Common Comments Made on Sanitary Sewer Plans

**Presentation to
Building Industry Association of Central Ohio**

By: Delaware County
Sanitary Engineer's Office
February 4, 2015

Common Comment #8

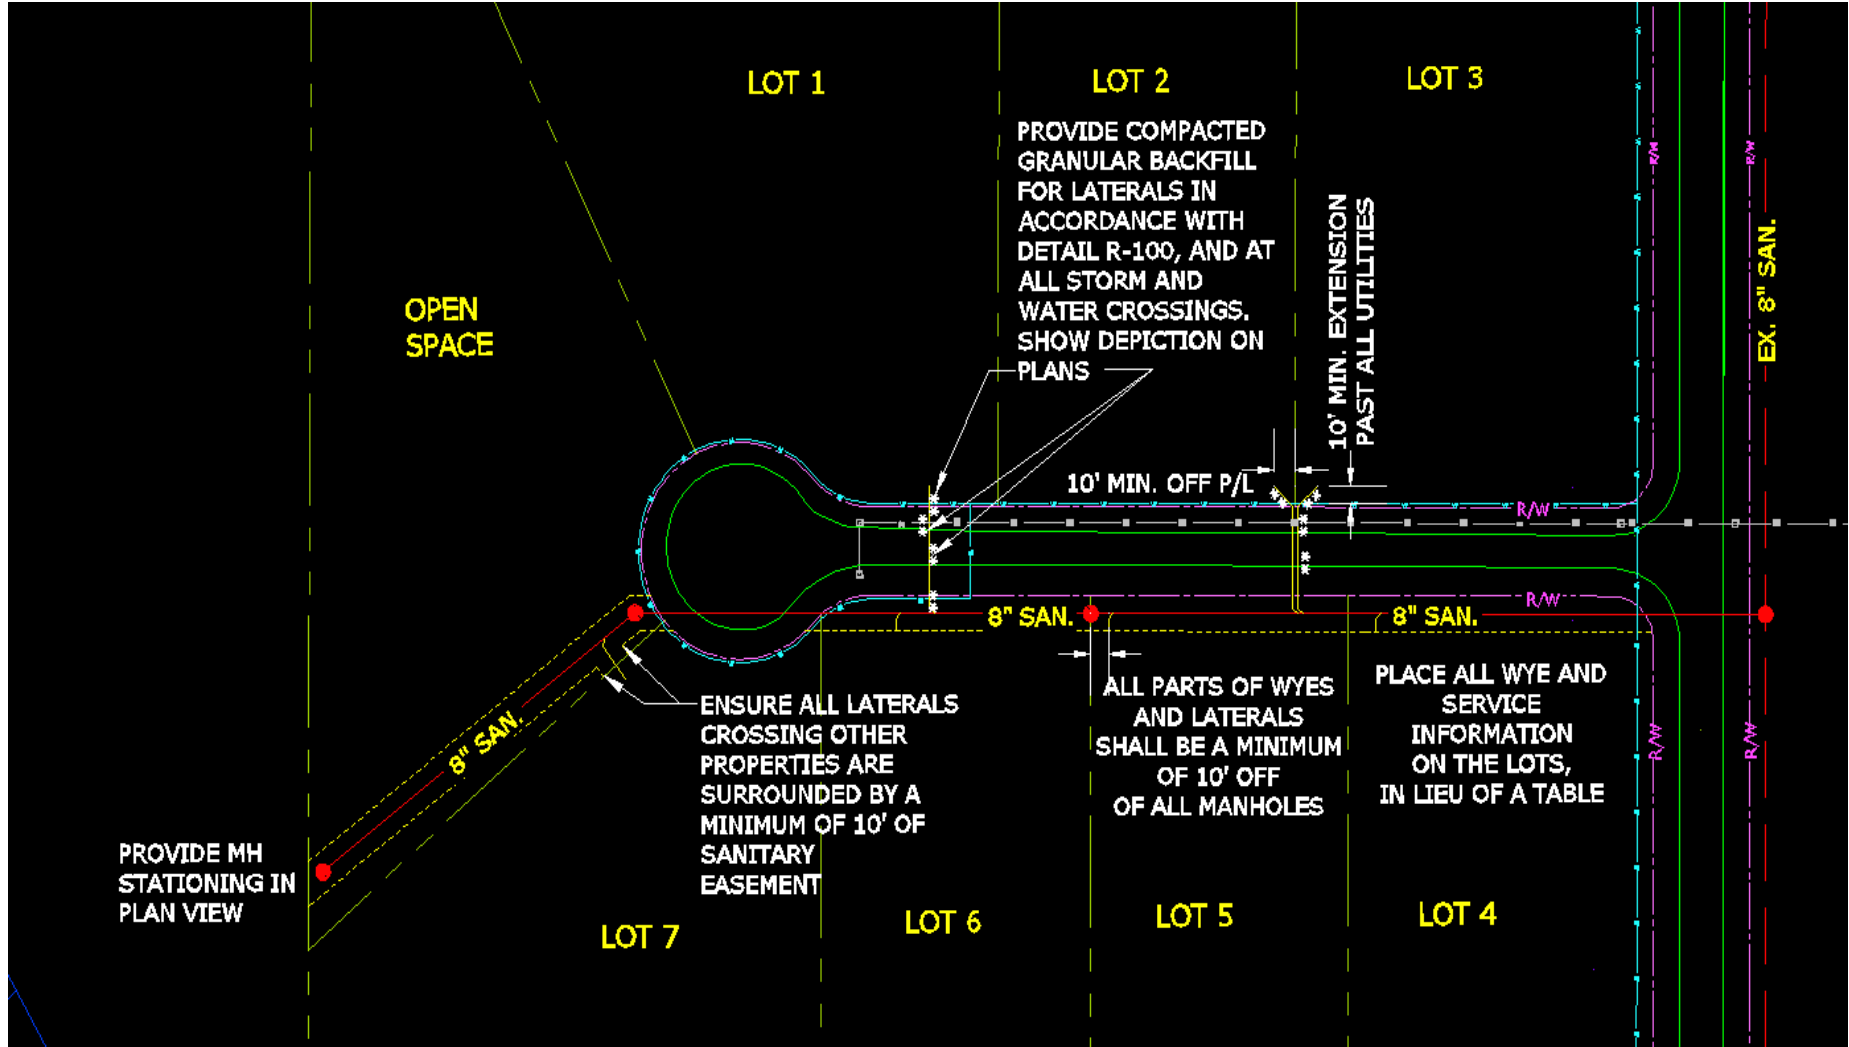
Various Sanitary Lateral Comments

Common Comment #9

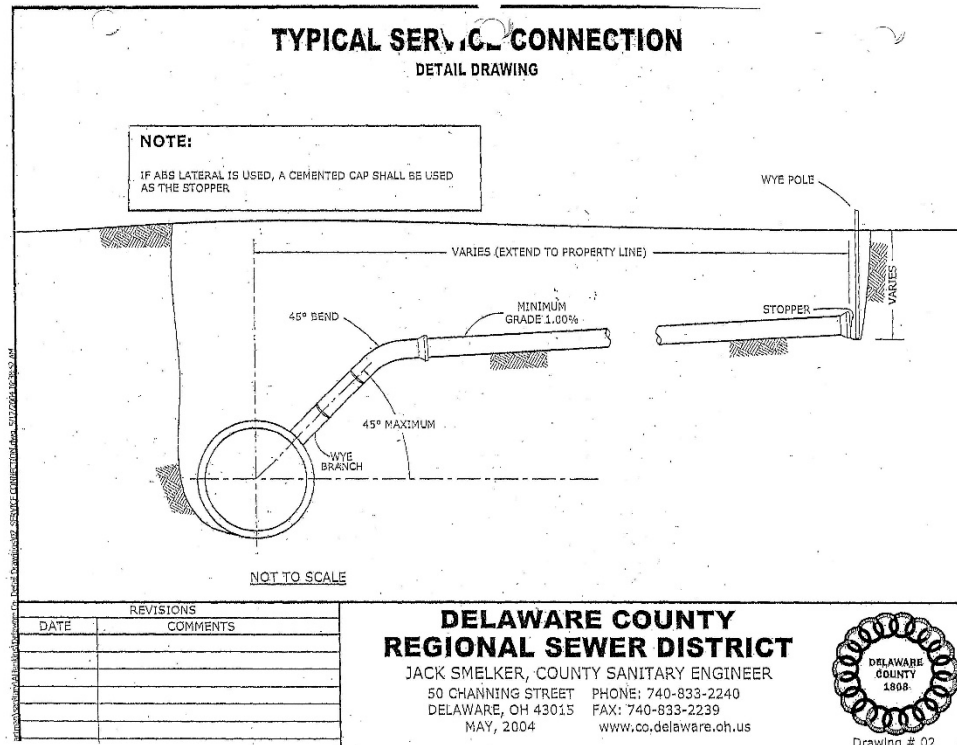
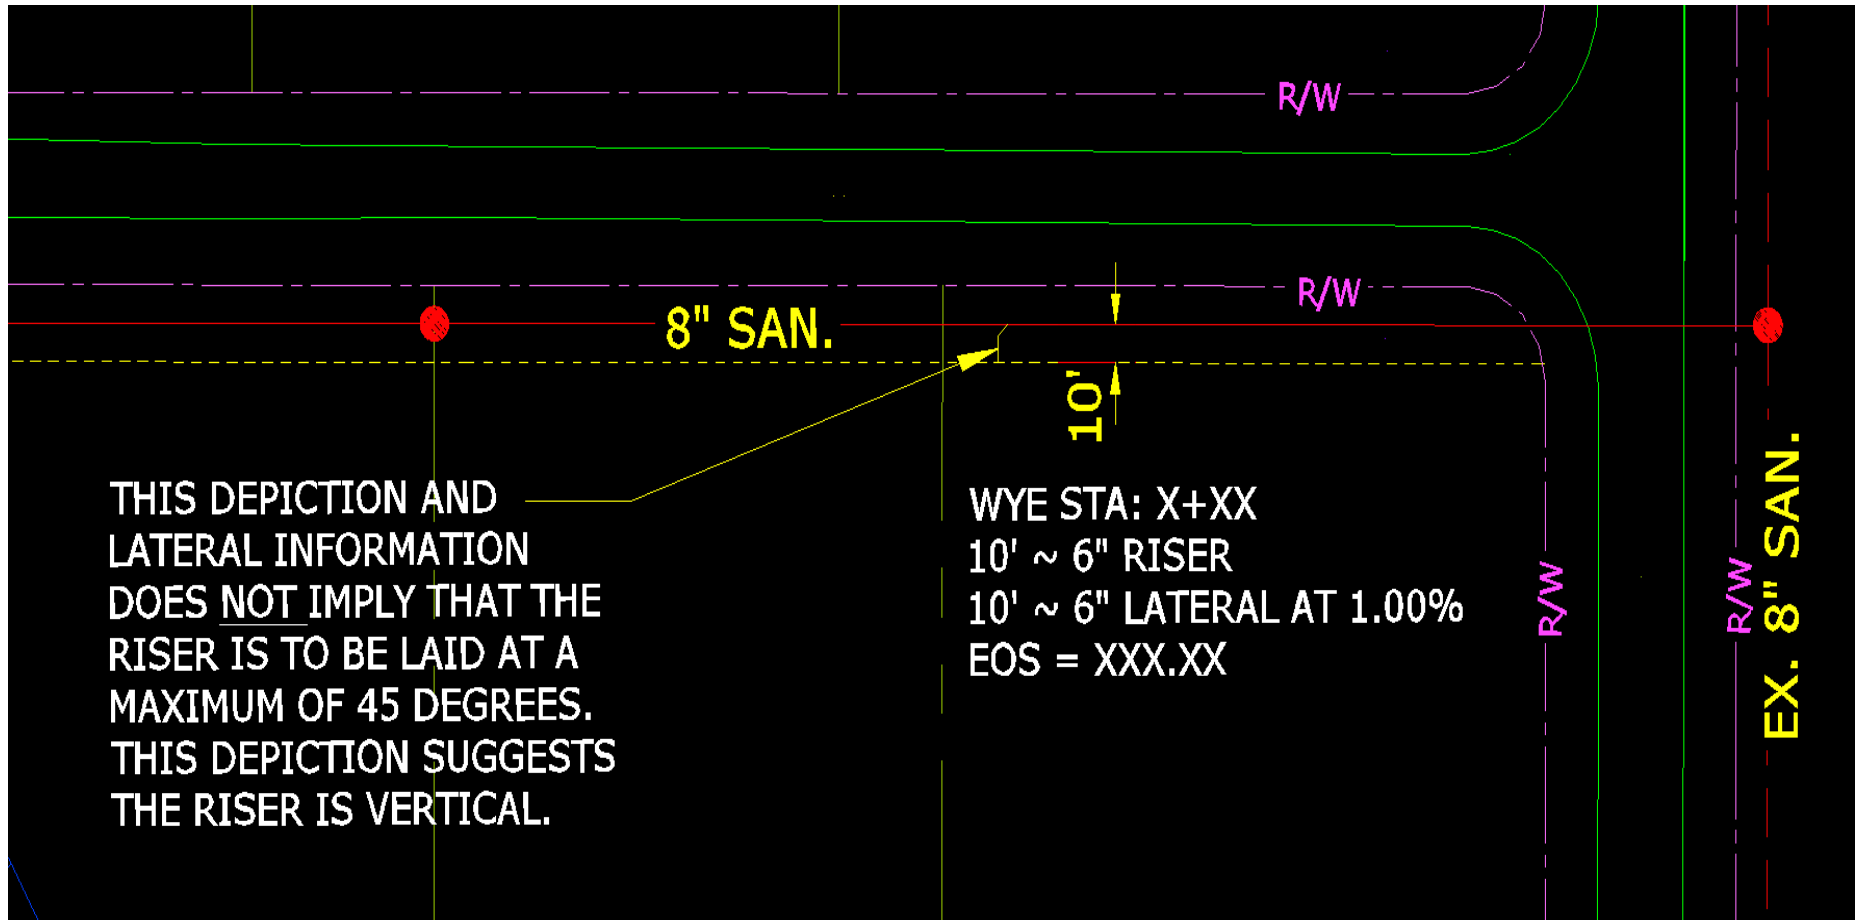
Please Ensure Riser Information Reflects a 45° Angle

Standard Drawing 02 depicts a maximum 45 degree angle for risers without concrete encasement
